April 13, 2022  
Subject: Reconstruct Terminal Apron  
State WIN: 020655.07  
AIP Project No. 3-23-0036-XXX-2022  
Location: **Augusta**  
**Amendment No. 1**

AUGUSTA STATE AIRPORT  
RECONSTRUCT TERMINAL APRON

**CONSTRUCTION SAFETY AND  
PHASING PLAN**

DRAWING NO.  
**G1.4**

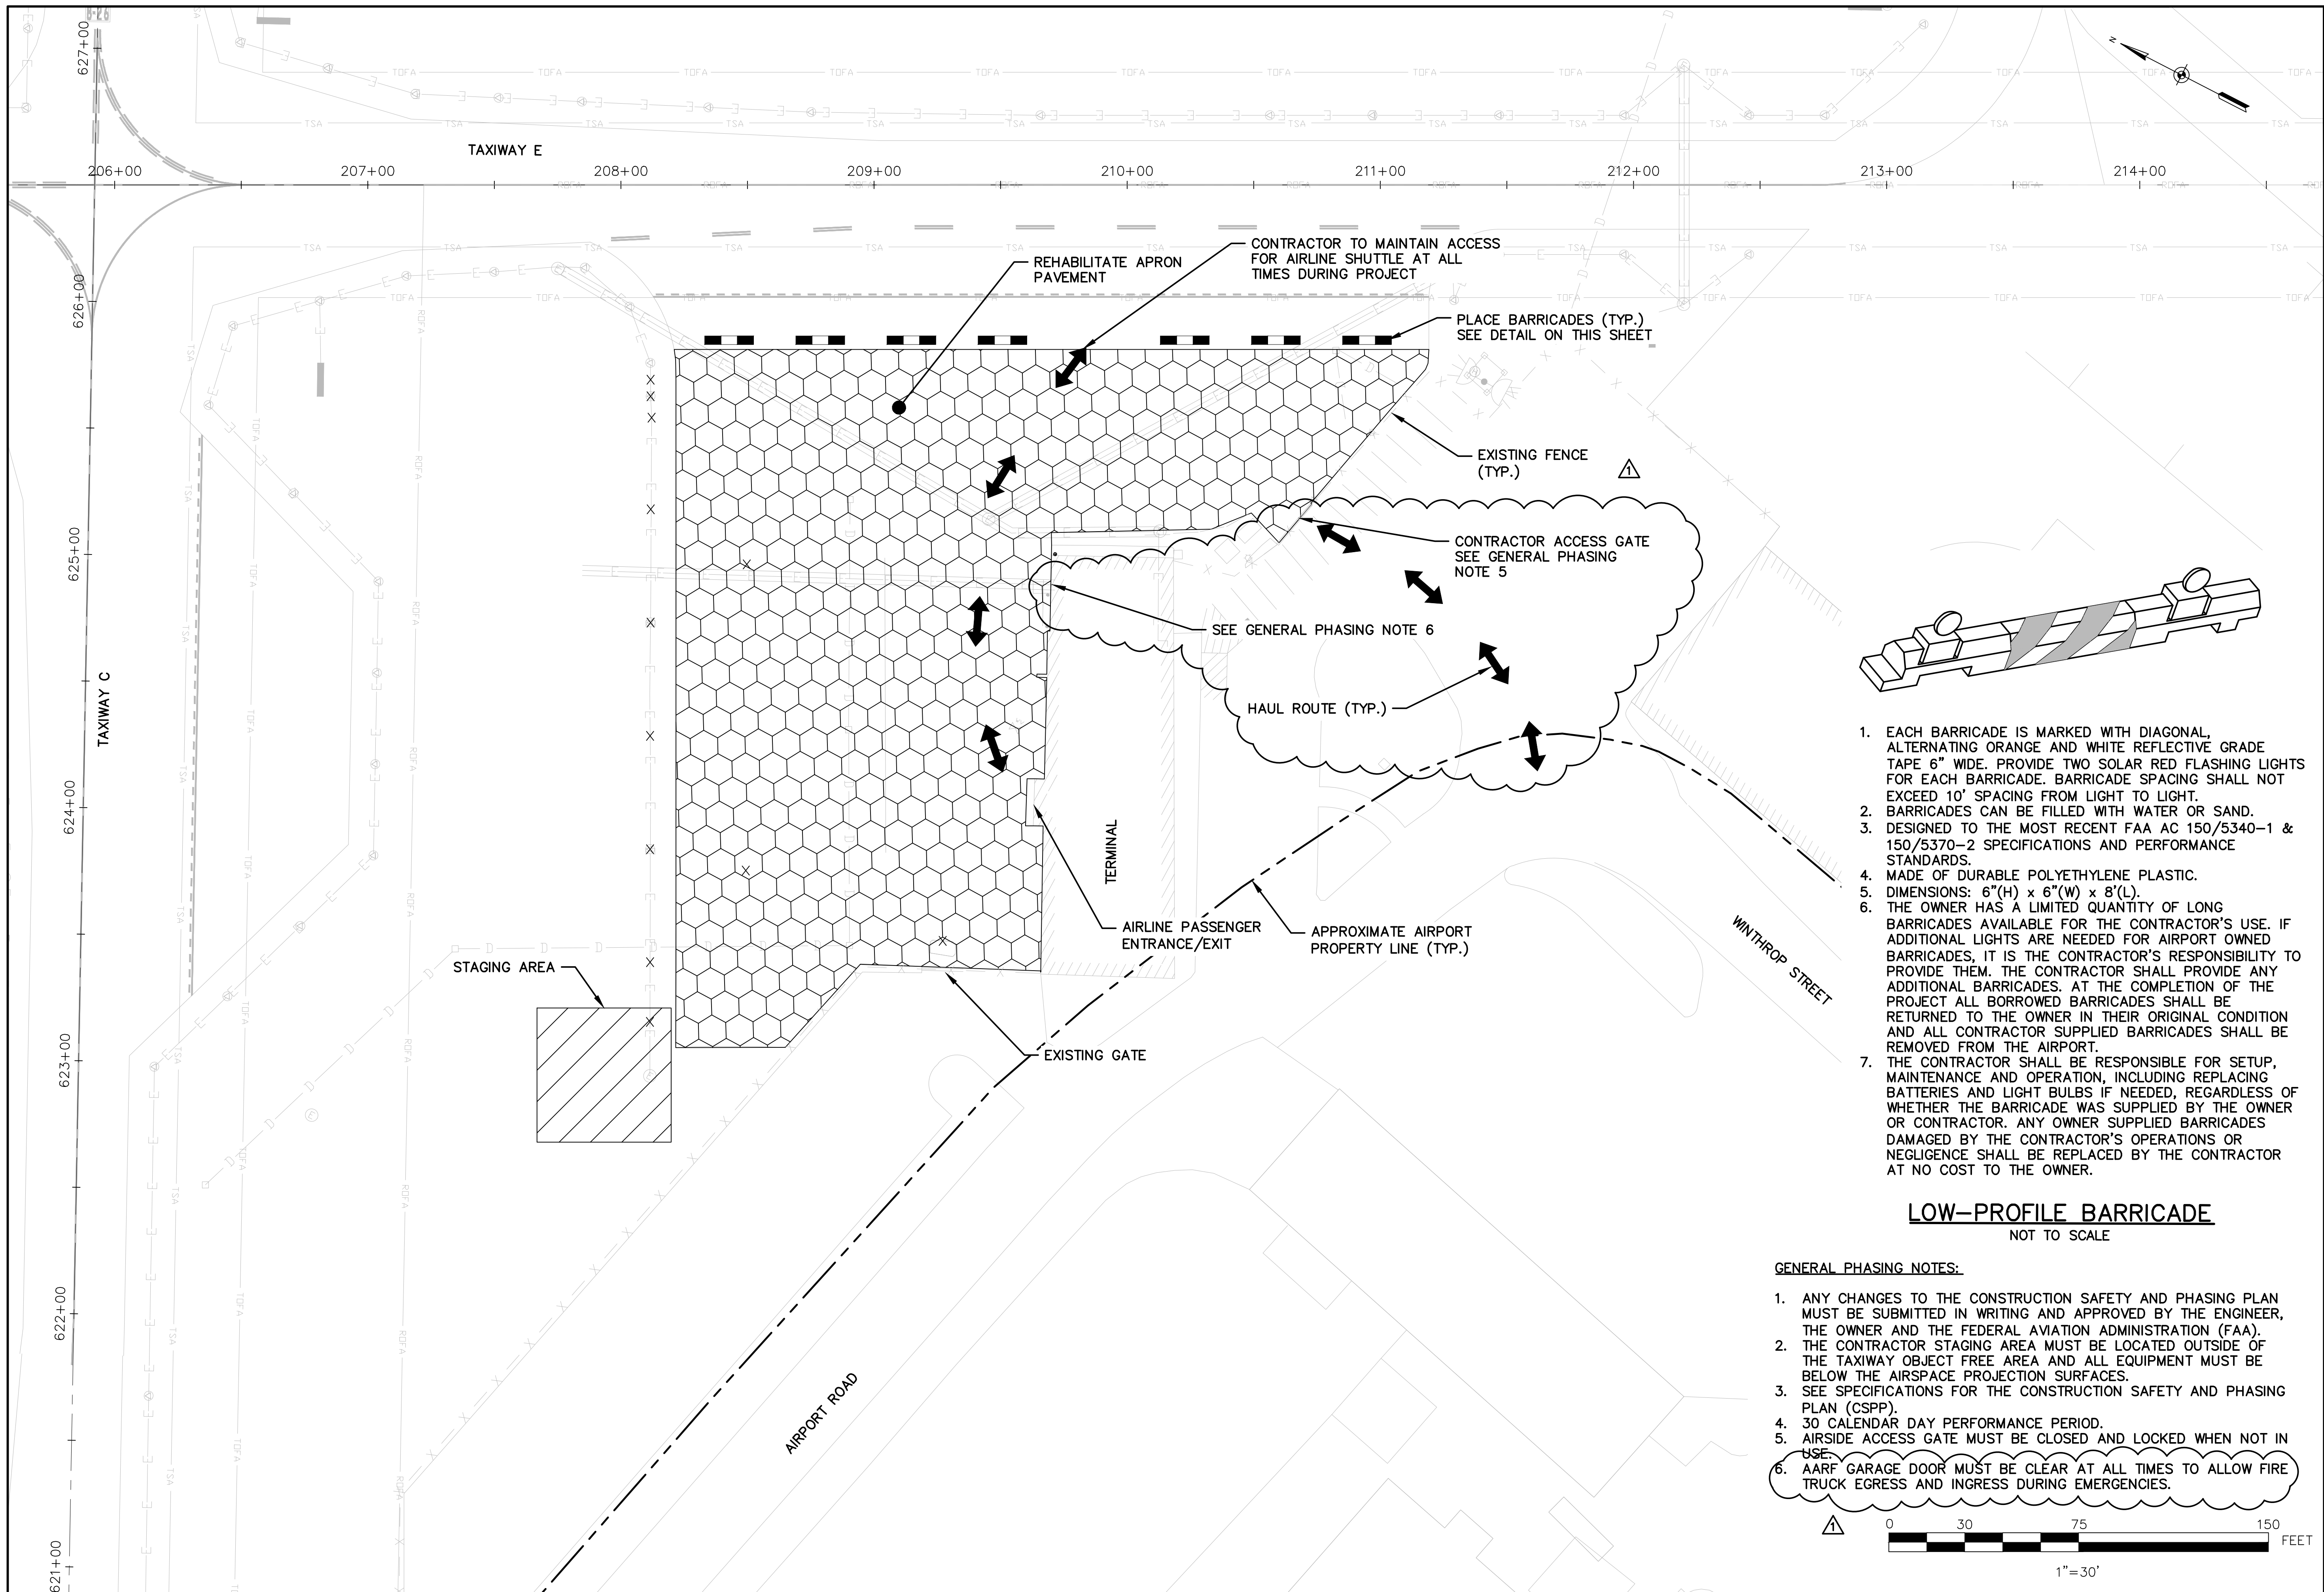
REV. NO.	DATE	DESCRIPTION	BY
1	4/12/22	REVISED ACCESS LOC./ARFF NOTE	NEG
2	4/1/2022	BID DOCUMENTS	JAK
